Patio Homes

The following items are conditions for permit issuance and strict compliance is mandatory.

FIGURE R602.10.6.4
METHOD CS-PF—CONTINUOUSLY SHEATHED PORTAL FRAME PANEL CONSTRUCTION

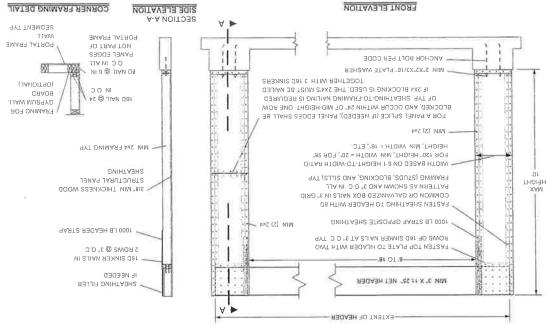
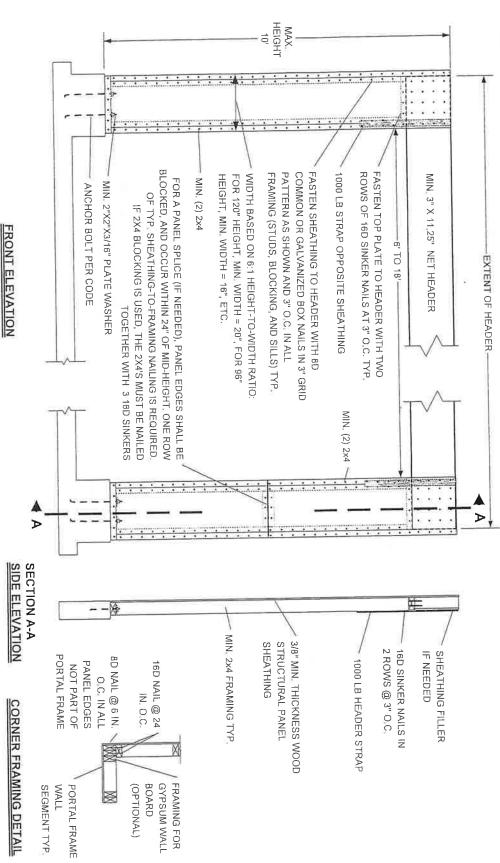
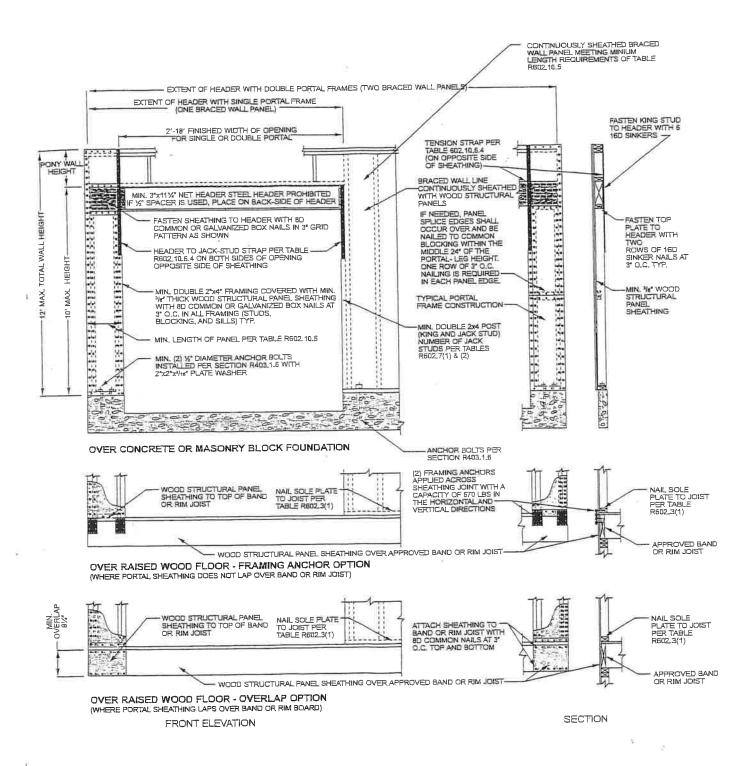
- 13. No final building inspection will be conducted prior to the installation of a water meter and a remote water meter read out.
- 14. Wall section on the front of the garage less than 2'-8" wide shall be braced wall panels.(see attached) MSBC1309/R602.10
